Submission on Solar Access for Design and Place SEPP

Image 1: View from Sun at 8am in Gosford showing impact Presidents Hill has on solar access.

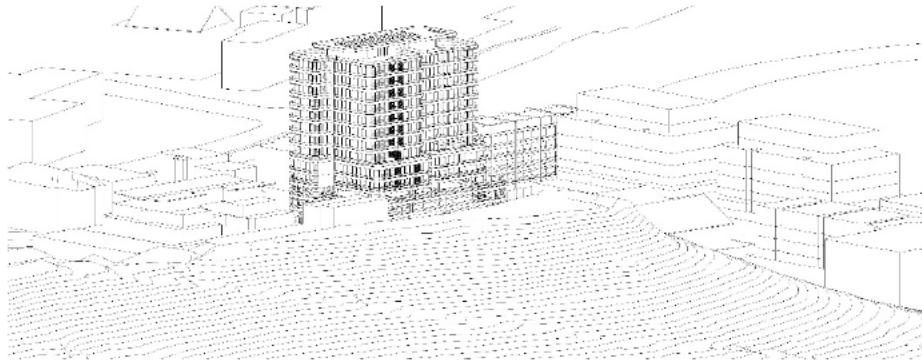
Design and Place SEPP is investigating extending the hours of compliance to beyond 9am to 3pm. Whilst we agree that 9am to 3pm is not appropriate for every site there are issues with this being extended as a blanket rule across all of NSW. An example below is an 8am View from the Sun for a site in Gosford LGA, but this could be replicated in nearly every LGA in NSW. Due to the large changes in topography, at 8am there are a lot of sites that are overshadowed by natural topography that sometimes could be over 1km away. If the hours were to be extended from 8am to 4pm, there needs to be a much more rigorous test undertaken to ensure that enough context is modelled (for example a 1km radius from the site including all buildings and natural topography).

We agree that there are definitely cases where the extended hours of 8am to 4pm are relevant and should certainly be considered, but there needs to be a rigorous test put in place. The case that is most often referred to when trying to extend the hours to 8am–4pm is *Botany Development Pty Ltd v Council of the City of Botany Bay* [2014] NSWLEC 1073, at paras. 79 through 87. Here the commissioner granted the extended hours due the sites long east west axis with a street to the southern side which leads to a certain design outcome. He agreed that *“the sunlight available between 8 am and 4 pm, the orientation of the site and the design that seeks to maximise solar access to the northern face of the building.”* (line 87). Based off that, there are sites in NSW that would benefit from extended hours

Hours should NOT be extended as a blanket rule across NSW. This should only be done in very dense urban settings such as within the Central Business District of Sydney. Within the City of Sydney, there is a context model that is purchased from the City of Sydney which leads to highly accurate solar analysis. It would achieve a theoretical rule of 1km radius of the site being modelled.

It is our submission that the hours of solar access should remain limited to the 9am to 3pm window on a state-wide basis until a rigorous test is included regarding accuracy and distance of context modelling.

Image 3: Sketch showing even with a 1m solid upstand, glare occurs in apartments. This is best combatted by using matt surfaces.

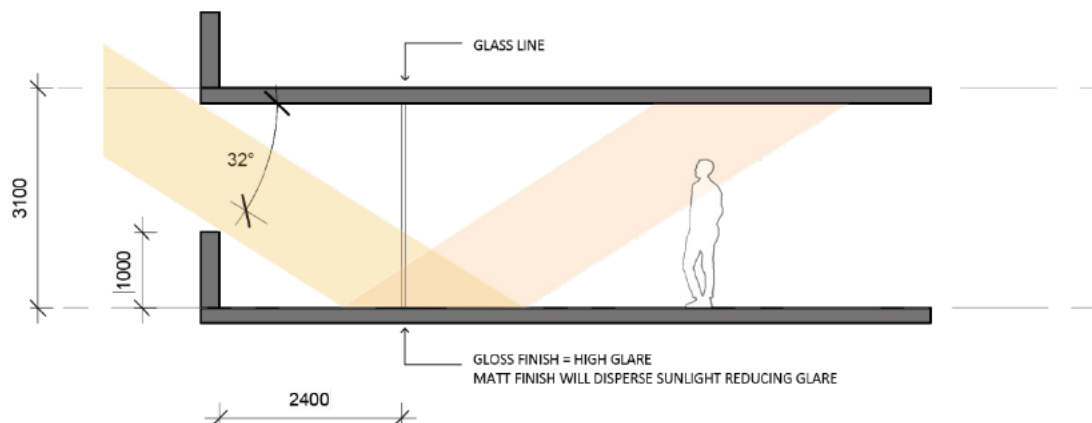
Whilst we agree glare can be an issue in some apartments, the above will not solve that problem. If we are looking at say the winter sun which is at 32 degrees altitude, a 1m no glass portion will not prevent glare for anything beyond the first 2m of the balcony (see diagram below). Usually, a north facing apartment will have a balcony in front of the living room and thus if the sun is at 32 degrees and there is a solid balustrade, it is only stopping the sun from reflecting off the floor of the first 2m of balcony. Typically the most effective way to combat glare is to change the reflectance of the floor and wall materials within the apartment as this has the greatest impact (gloss verse matte tiles/floorboards for example).

Putting limits on the amount of solid or glass surfaces is not the best way to combat glare within apartments.
